Appendix 6 – Technical Notes

DUBLIN AIRPORT
Technical Note 001
Airbridges

CIP2020+ Airbridges Rates Review

Re: Response to Dublin Airport CIP2020 Efficiency Assessment (Steer - May 2019)

Figure 1 – High Mast Light Installation

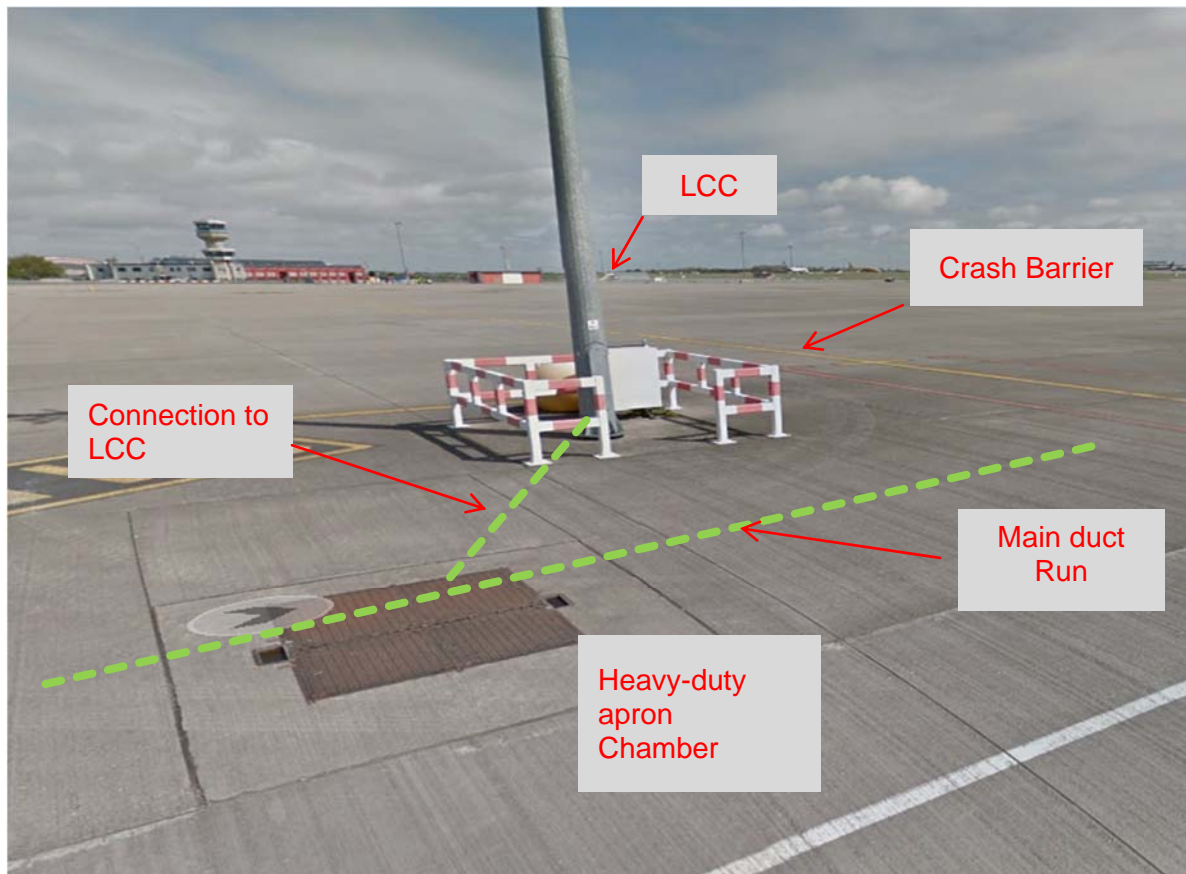
In order to clarify the scope and breakdown of the high mast lighting rate of €XXXX/Item, Dublin Airport have provided within this technical note further breakdown of the Dublin Airport rate as well comparable project costs which were reviewed when evaluating the rates within the estimate. As noted, the rate included is based on subcontractor costs at Dublin Airport for project D16006 Apron 3-4. As advised we are unable to share the full tender document presented in the Steer Site Visit Meeting on June 13th at this time, however we have provided a cost summary in Appendix 1 which details the scope items within the works package.

As advised within the Steer Site Visit Meeting, the following scope is included within the high mast lighting rate:

The high mast lighting scope components noted can be referenced in the table below. This breakdown illustrates the build-up to the rate utilised within the Dublin Airport estimates. The rates consider the complexity of installing each high mast lighting column including the associated civils works with installation of new duct and cable as well as backfilling and pavement construction while in a live airfield environment.

It should be noted, the rate allows for a potential requirement to replace existing infrastructure which involves replacement of full cable and duct runs to termination point and upgrade of existing MCC control system to accept

the new installations with associated pavement works. The Dublin Airport rate of €XXXX/item is reflective of this complexity.

Figure 8. 9 Proposed Electrical Layout on 5M Apron

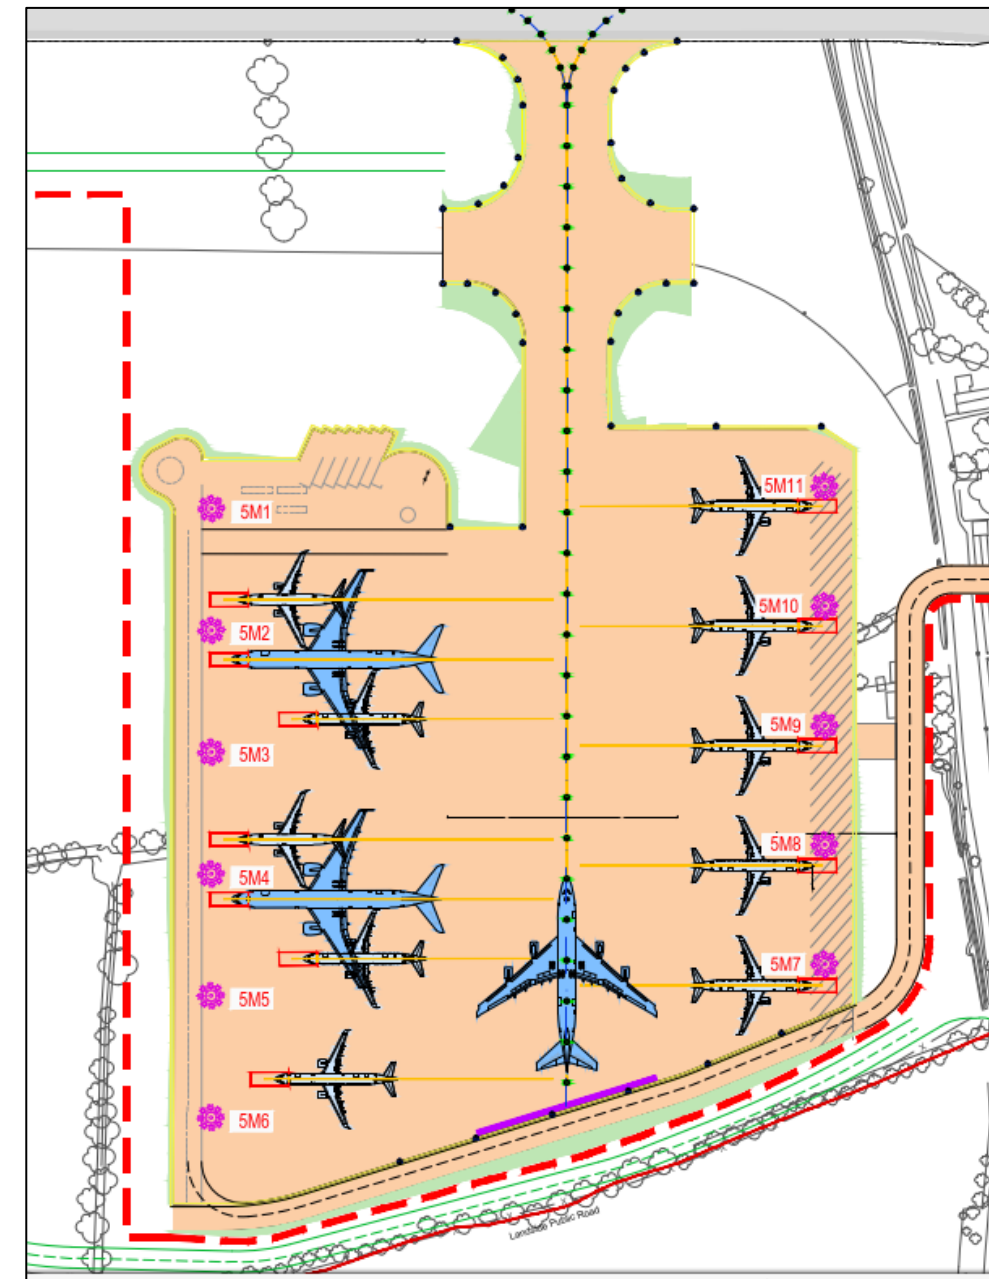
The proposed electrical layout for the 5M Apron is shown in Figure 7.11 below.

For further details on Figure 8.9 please refer to drawing: CIP20-03-AIR-A5M-STD-000-01-3030

Appendix 4 – 20.03.031 – PBZ Building Overall Floor Area

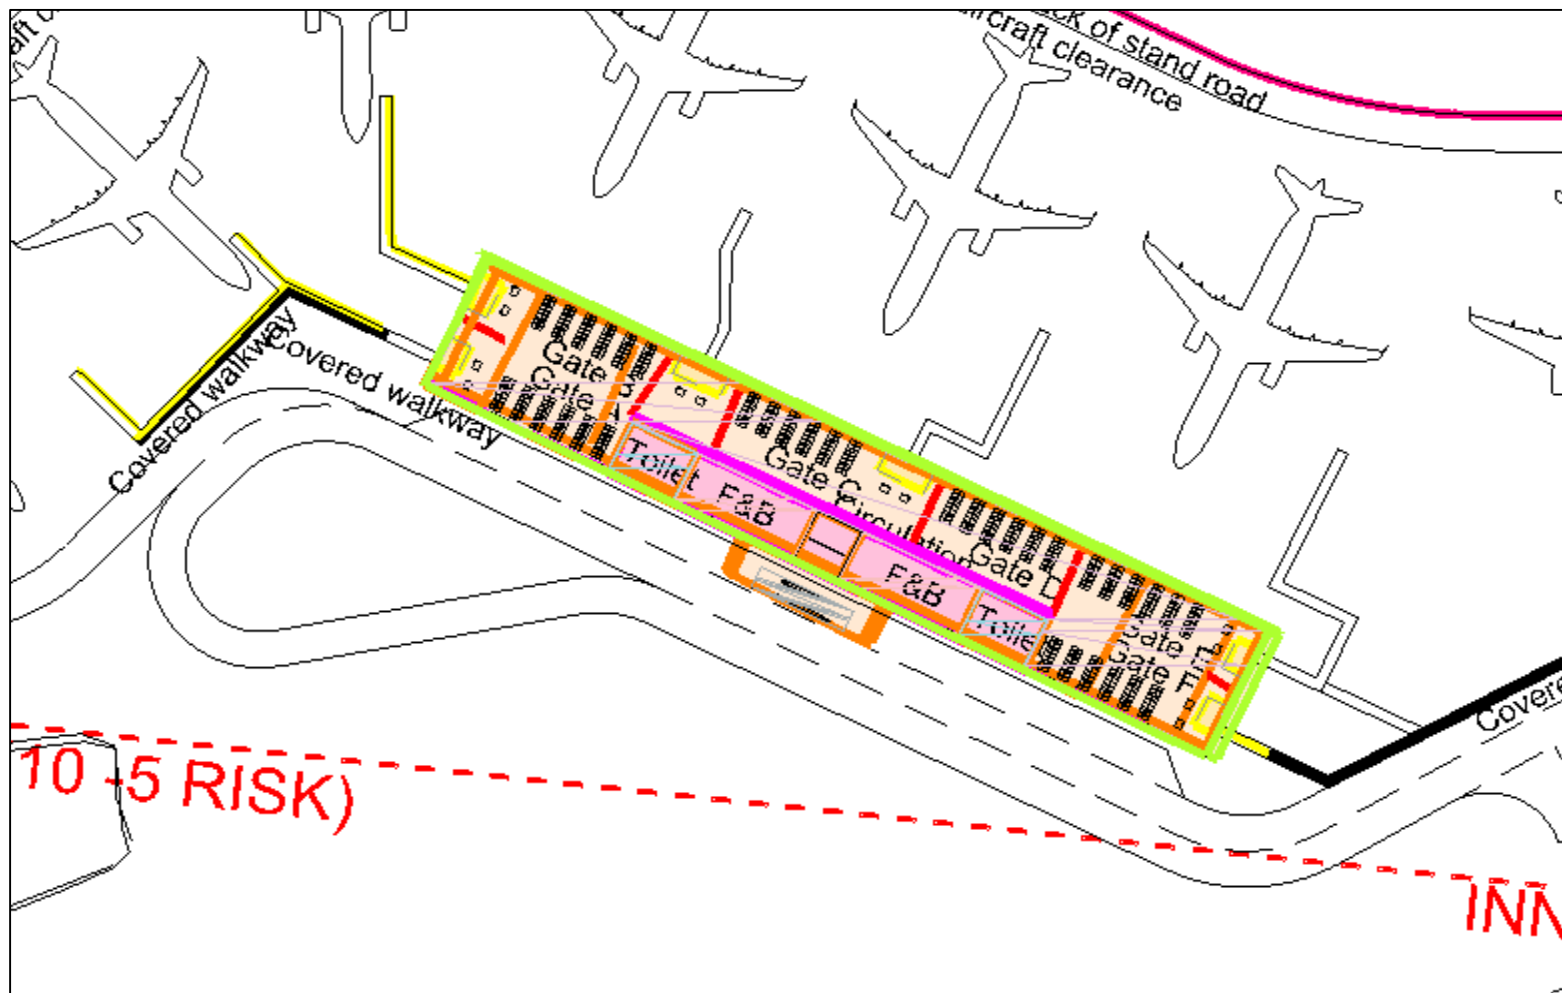
To provide further clarity on the above quantity variance (XXm²), Dublin Airport have attached the take-off drawing for the new PBZ building where this difference exists. It should be noted that this quantity variance creates a cost variance on other items which are linked to the overall floor area of module 1 i.e. structure and internal fit-out and services.

New PBZ Building Floor Area - XXXXm2

Figure 3 OCTB refurbishments, area measured

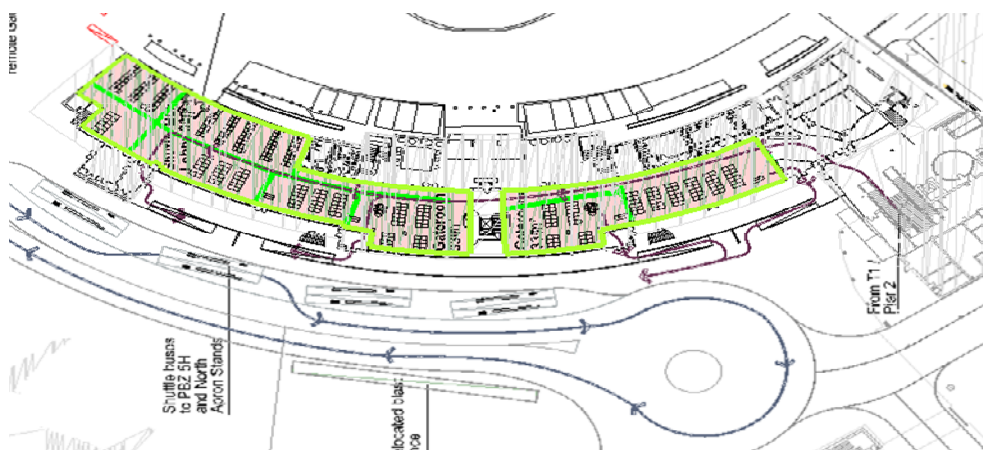
The Steer rates of €XXXX/m² and €XXXX/m² for refresh works within the OTCB results in a shortfall of approximately €XXXm compared to our efficient estimates not including associated reductions in allowances for phasing, design development, preliminaries, risk & contingency, design and management costs and escalation costs.

As a review against other projects completed within Dublin airport the recent tiling project on T1 departures level resulted in an outturn cost of €XXXX.m² as well as the T1 arrivals hall refurbishment which resulted in an outturn cost of €2,200/m². As noted albeit have underlying floor issues in T1 departures level floor we are conscious that there will be costs associated with the remediation of the existing sub-strata when refreshing the OTCB. We are also conscious that this is a listed structure, and all works in this area will probably done under supervision and must be done to level of detail and character which meets that of the original building. This level of finish is likely to be a condition of the planning for this facility.

Figure 4 T2 Check in hall, office and WC relocation

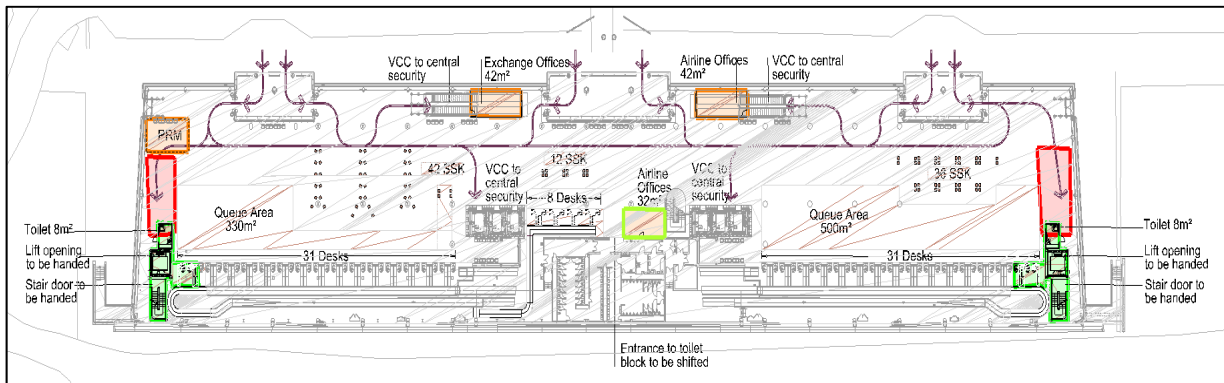
The Steer rates of **€XXXX/m²** and **€XXXX/m²** for alterations to WC's & relocation and development of various offices results in a shortfall of approximately **€0.86m** compared to our efficient estimates not including associated reductions in allowances for phasing, design development, preliminaries, risk & contingency, design and management costs and escalation costs.

In alignment with the previous Dublin Airport rate of **€XXXX/m²** allows for demolition and alterations, an element of new build shell & core and subsequent fit-out of the new WC's including all fixtures, fittings and equipment. It is also reflective of the costs of these works generally being undertaken as small standalone, piecemeal works.

Figure 5 T2 central search proposed expansion

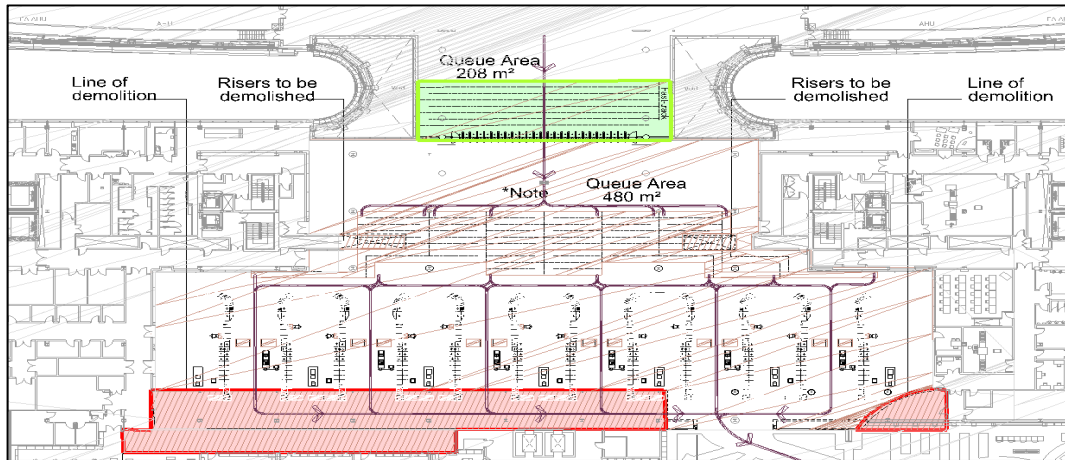
The Steer rate of **€XXXX/m²** for fit-out of the expanded T2 central search area results in a shortfall of approximately **€XXXm** compared to our efficient estimates not including associated reductions in allowances for phasing, design development, preliminaries, risk & contingency, design and management costs and escalation costs.

The Dublin Airport rate of €XXXX/m² is for direct construction costs associated with demolition, removal, disposal of existing floors, walls, ceilings and MEP services along with installation of and making good new finishes. The rate also takes account of any phasing requirements to complete this project in an operational airport, including any temporary works which are required to maintain the existing central search facility. As can be noted from the drawing above, these works will be undertaken in a critical area where passenger flows are vital for Dublin Airport and its customers. This scope of work will take significant planning and execution to maintain Dublin Airport reputation for excellent passenger experience.

Figure 6 Pier 3 immigration hall, measured retrofit areas

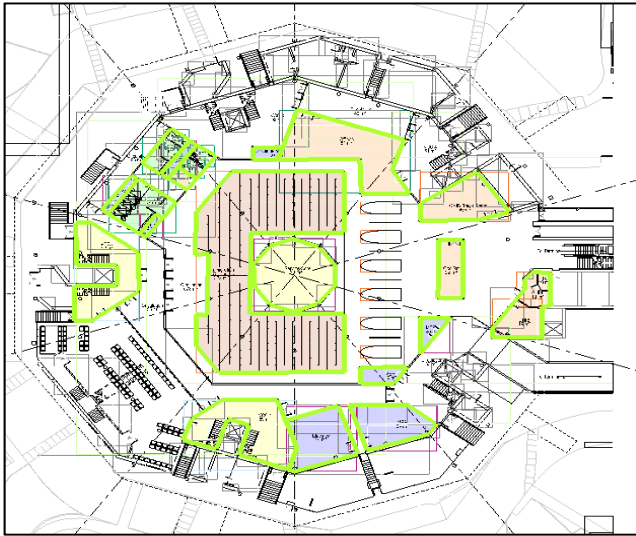
The Steer rates of €XXXX/m² for development of new electrical room, €XXXX/m² for alterations to queue space and €XXXX/m² for development of a new WCs results in a shortfall of approximately €0.54m compared to our efficient estimates not including associated reductions in allowances for phasing, design development, preliminaries, risk & contingency, design and management costs and escalation costs.

Pier 3 is an incredibly congested space, as noted elsewhere over the course of the CIP the volume of passengers using this space ensures that there are very limited periods where works can proceed uninterrupted. It is notable that this work needs to take place within this, very active environment and will need to be undertaken in micro phases to succeed.

Figure 8 T1 roof plan view

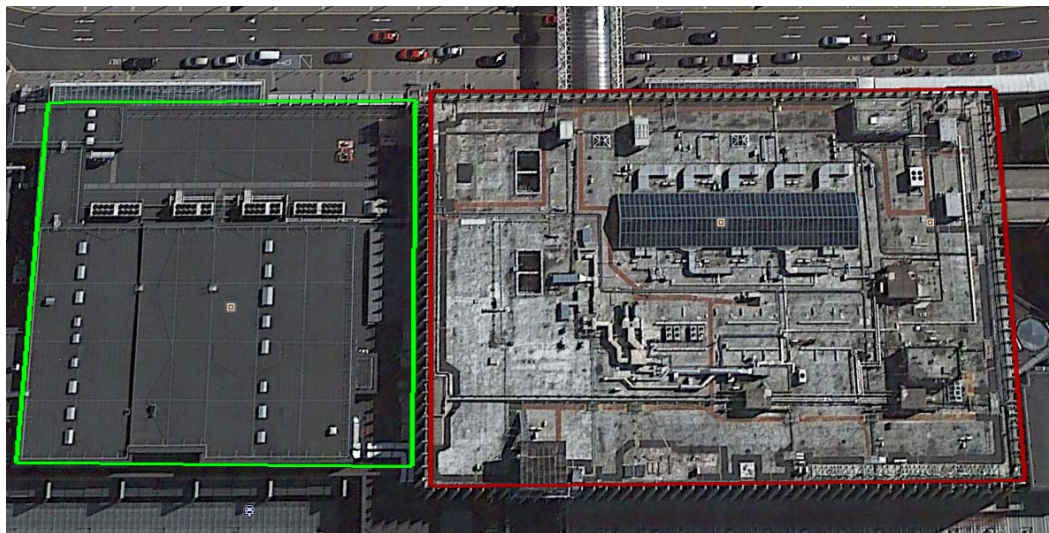
The Steer rates of ~~€XXX/m2~~ for the strip out of existing services are insufficient to complete the works. The works will include the strip out of the redundant services, jacking up of remaining services to allow for new roof finishes to be installed, some equipment will need to be disconnected and some equipment will require a temporary substitute in place during the planned down time. The rate of ~~€XXX/m2~~ included by Dublin Airport for services strip out is based on the costs of recent roof finishes projects completed in the airport under the current CIP namely Roof Upgrades Phase 2 & 3.

Figure 1 Skybridge dual escalators at arrivals journey

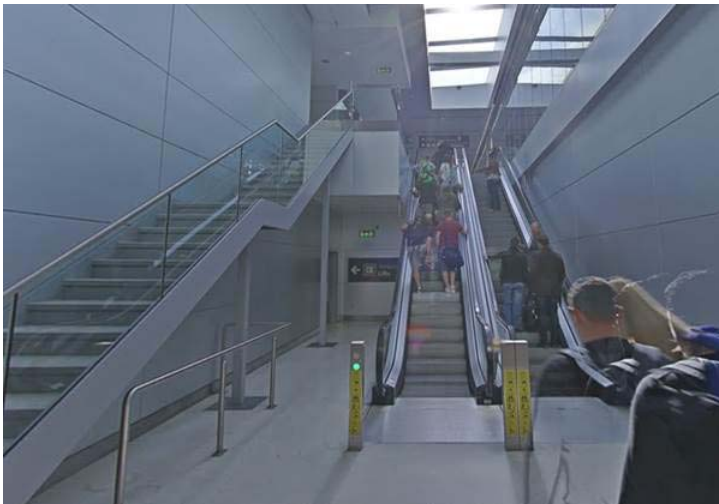
The purpose of this technical note is to provide further detail on the allowances included within the CIP estimates covering escalators in Pier 5 (CIP.20.03.029). A variance of approx. -~~€XXXk~~ exists between the Dublin Airport estimate and the Steer estimate due to a difference in count of -2no. escalators in the new Pier 5.

This assumption was not captured within the Dublin Airport estimate and as a result only dual escalators were allowed at the arrivals core which services between apron level and level 20, and single escalators from level 30 to apron level in the departures core, as opposed to dual escalators. The escalators required within the cores in each fixed link were omitted entirely. The design assumption for dual escalators was on the basis that the same level of service would be required as per the T1 skybridge.
